Title: Electronic Gauge Cluster Warning Lights in LT and RH

Applies To: LT and RH built without Electronic Stability Control Cluster

Replacing an Electronic Gauge Cluster (EGC) that is not equipped with Electronic Stability Control (ESC) will require opening a Technical Service case file, and requesting a change to 0597 feature codes in the Body Control Module (BCM) to accommodate the ESC light in the new EGC.

◦ Figure 2 shows the replacement EGC with ESC

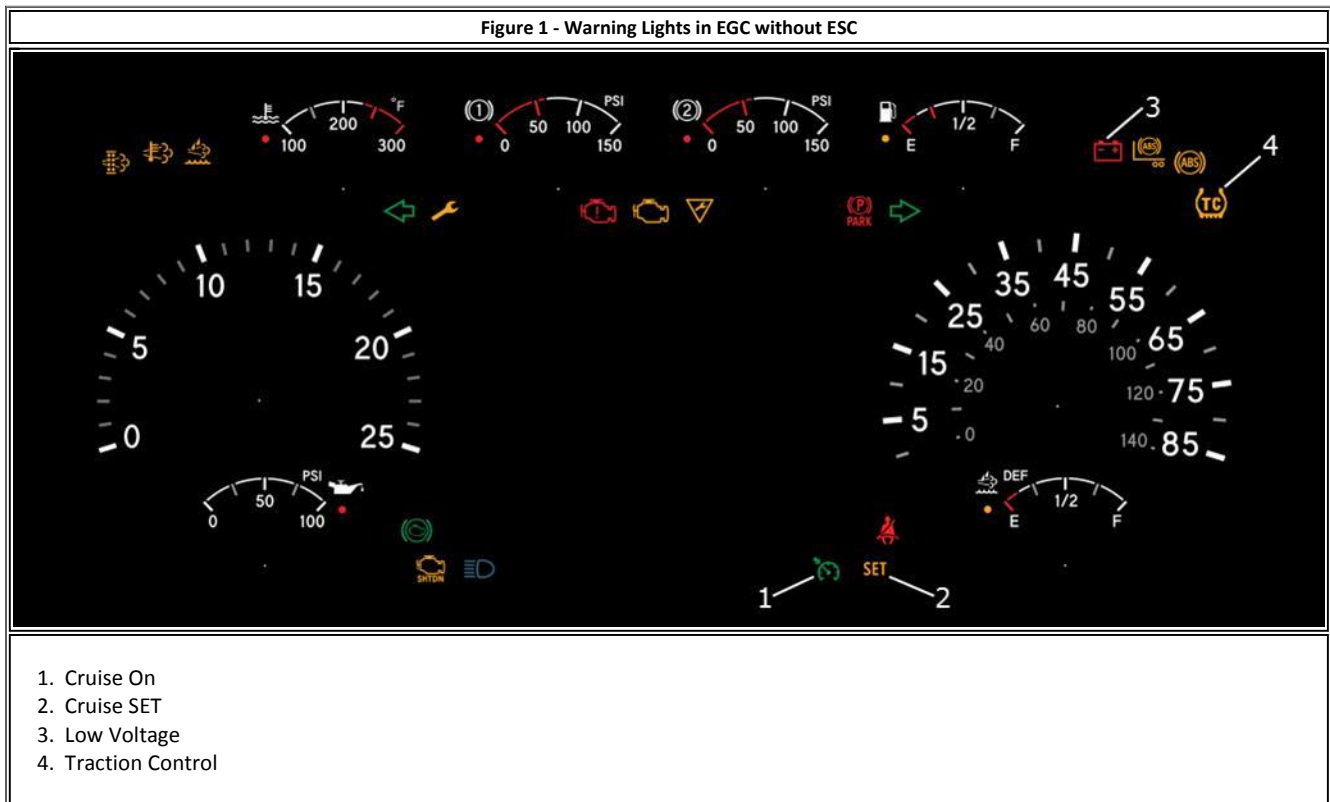
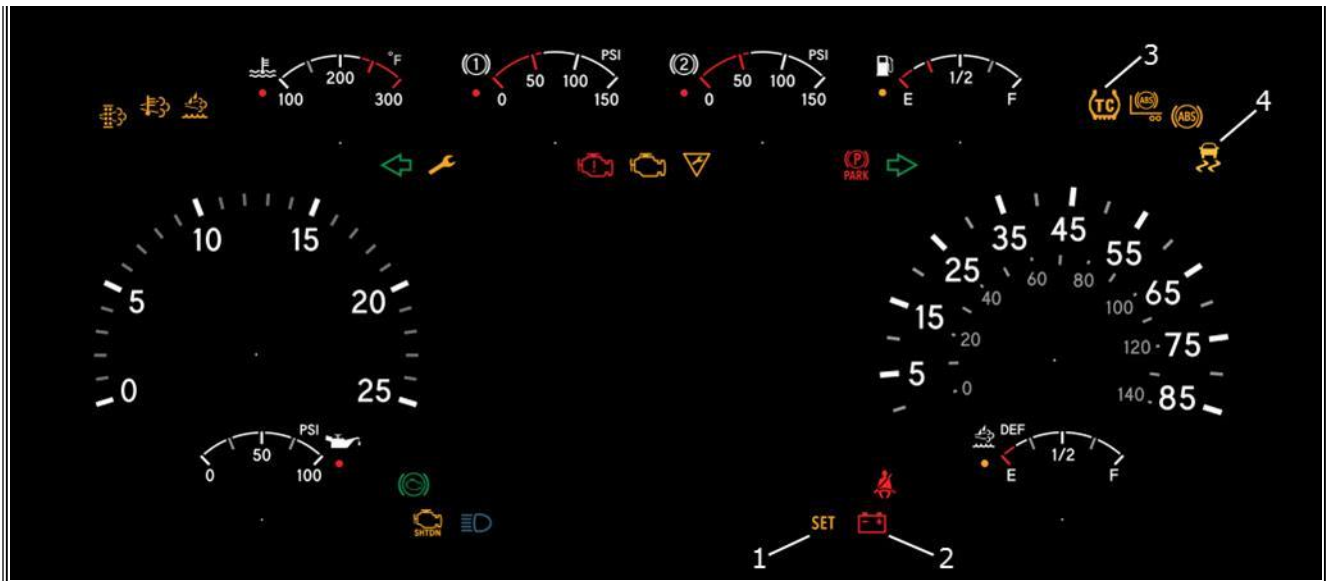
- 1. Cruise SET
- 2. Low Voltage
- 3. Traction Control
- 4. Electronic Stability Control

Gauge / Warning Light	Original 0597 Feature Code (Remove)	New 0597 Feature Code (Apply)
Voltmeter / Battery	0597127 - BCM PROG, VOLTMETER for Auxiliary Gauge *If Equipped	0597179 - BCM PROG, VOLTMETER for Auxiliary Gauge, cluster Version #2 *If Equipped
Voltmeter / Battery	0597128 - BCM PROG, VOLTMETER for Virtual Gauge	0597180 - BCM PROG, VOLTMETER for Virtual Gauge, Cluster Version #2
Traction Control	0597050 - BCM PROG, TRACTION CONTROL IND ; Mud/Snow; Traction Warning Light, for Hydraulic Brakes or Air Brakes, Not Including Trailer	0597191 - BCM PROG, TRACTION CONTROL IND ; Mud/Snow; Traction Warning Light, for Hydraulic Brakes or Air Brakes, Not Including Trailer, Cluster Version #2
Cruise Control	0597081 - BCM PROG, CRUISE CONT STEER WHEEL	0597177 - BCM PROG, CRUISE CONT STEER WH Cluster Version #2
